UNITED STATES PATENT AND TRADEMARK OFFICE

Office Action Summary

10/803,918

DETAILED ACTION

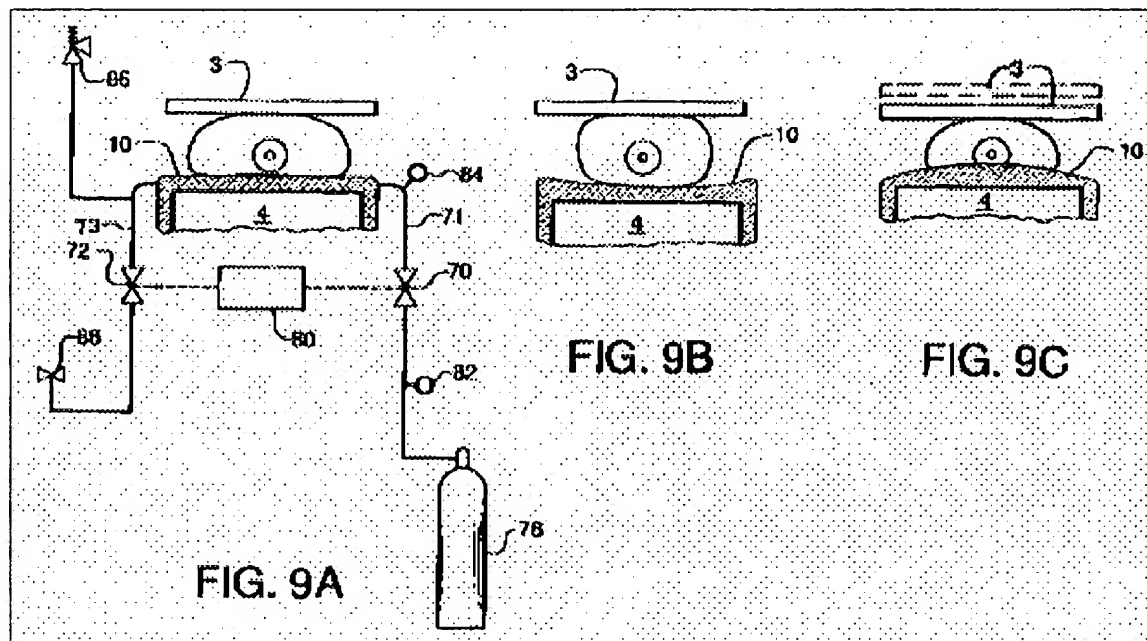
8. With respect to claims 17 and 32-35, Galkin discloses a pressurizing arrangement in a mammography equipment piece that is configured to provide a well defined and comfortable positioning and fixation of a human breast of an examined person and wherein the mammography equipment piece includes an x-ray source (Fig. 1, 1) and an examination area for the breast, as well as an upper and a lower compression plate (Fig. 9A - 3 & 4), said pressurizing arrangement comprises: an essentially elastic container (10) constructed of an x-ray permeable material and configured to be located within the examination area between the upper and lower compression plates, said elastic container comprising an inlet (71) for receiving a

medium which expands the container and presses the breast against an oppositely positioned compression plate (Figs. 9B & 9C).

With respect to claim 19, Galkin discloses the container forms a pillow positioned on the lower compression plate in the examination area (see Fig. 9A above).

With respect to claim 20, Galkin discloses a contact surface of the container substantially surrounds the breast (see Fig. 9A above).

Figure 3G depicts this:

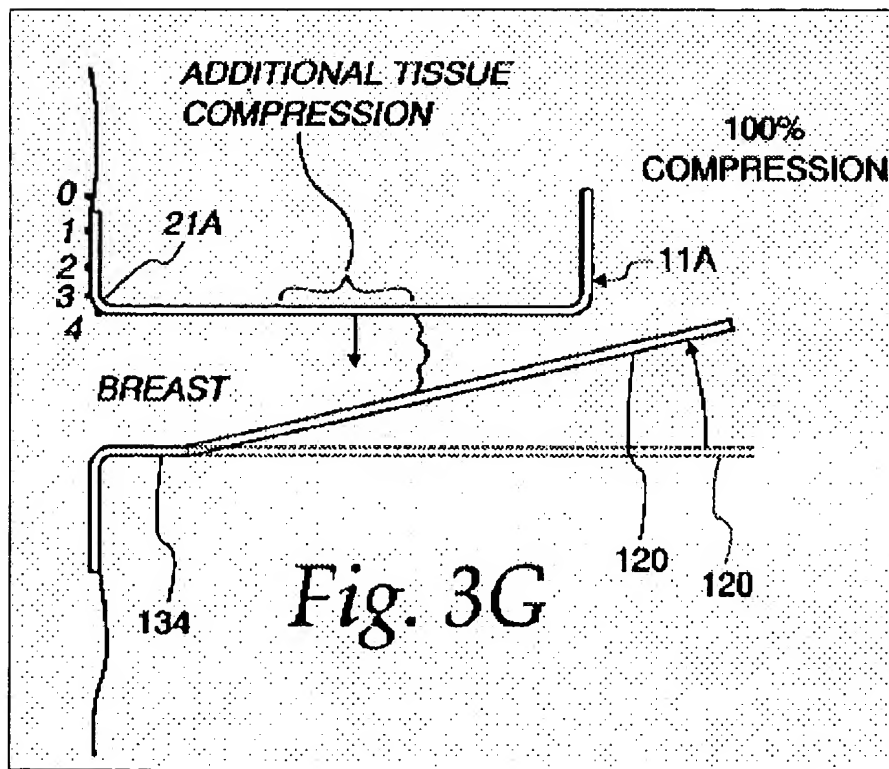
Galkin does not disclose the container being arranged to expand into an inclined configuration having a lower and a higher section, said lower section being closest to the body of the person during examination. Livingston teaches (paragraph 0010), "Now there has been a general recognition that good and more uniform compression is most desirable in mammography systems, as also a recognition that the proposed systems should address the issue of less patient's discomfort because many of the patient's find the mammography operation to be painful." To solve these problems, Livingston discloses (paragraph 0018):

[0018] In accordance with a preferred embodiment, there is provided an improved method and apparatus for **compressing substantially the posterior breast at a location adjacent the chest wall** and to stabilize this tissue while in a compressed state without pushing of the posterior breast tissue back into the chest wall and from the imaging area, **and then to compress the middle and anterior tissue with an inclined portion providing a substantial compression of the middle and anterior**

breast over a wide range of sizes, shapes and densities of breasts without an interfering shadow in the imaging area and without pushing the posterior tissue back into the chest wall and from the imaging area. Preferably, this is achieved by a patient and operator user-friendly method with less discomfort to the patient. By way of an example only, the initial compression of the posterior breast tissue at the chest wall between the paddle and bucky is achieved by the paddle traveling downwardly through about six centimeters without the patient feeling any significant discomfort; and then rather than displacing the paddle vertically relative to the bucky where the patient feels significant discomfort and/or pain, the posterior ends of the bucky and paddle remain at this 6 centimeter displacement and an inclined portion on the paddle or bucky is swung to compress the middle and anterior breast portions.

It would have been obvious to one of ordinary skill in the art at the time the invention was made to modify the Galkin elastic container (10) to assume the shape during imaging taught by Livingston, to provide for better image quality as well as to provide for patient comfort. Livingston teaches that this configuration for compressing the breast

causes little discomfort or pain even though there may be 90 or 120 newtons of force applied at the posterior breast tissue (paragraph 0026).
